## Product Change Notice (PCN)

**Subject:** Addition of Assembly Process and Final Test site for the RH850/P1x-C series.

**Publication Date:** 12/22/2022

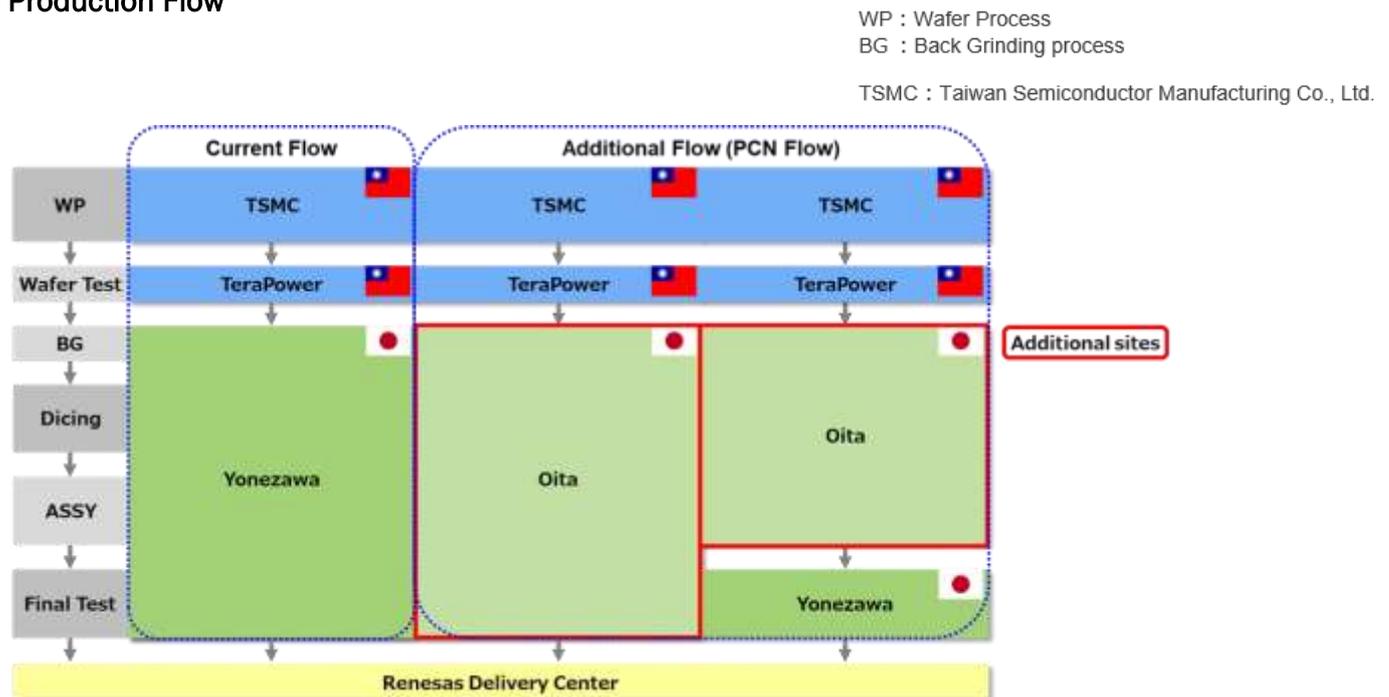
Concept of site addition

- (1) The production flow of added site is equivalent to existing sites.
- (2) Additional site's machines and the standard process are used for Assembly Process, but the same reliability as existing sites is secured.
- (3) Renesas will manage inspection and process control, and the same control as existing sites is used.

Packing

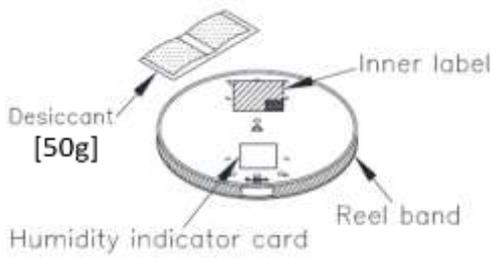
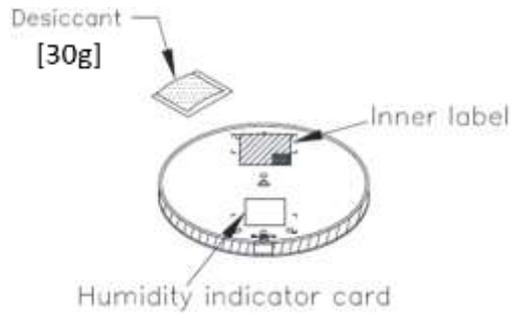
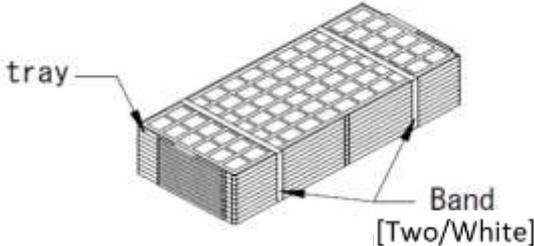
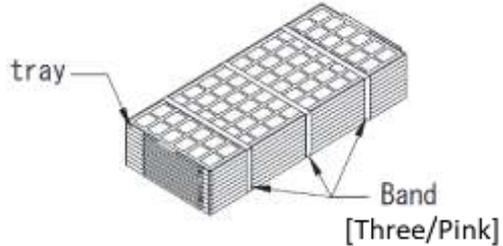
Yonezawa	Oita
Tape & Reel Packing : Reel band (リールバンド)	 <p>Reel band</p>	 <p>No Reel band</p>
Tape & Reel Packing : Desiccant (乾燥剤)	 <p>Desiccant [50g]</p> <p>Inner label</p> <p>Humidity indicator card</p> <p>Reel band</p>	 <p>Desiccant [30g]</p> <p>Inner label</p> <p>Humidity indicator card</p>
Tray Packing : Tray Band (トレイバンド)	 <p>tray</p> <p>Band [Two/White]</p>	 <p>tray</p> <p>Band [Three/Pink]</p>
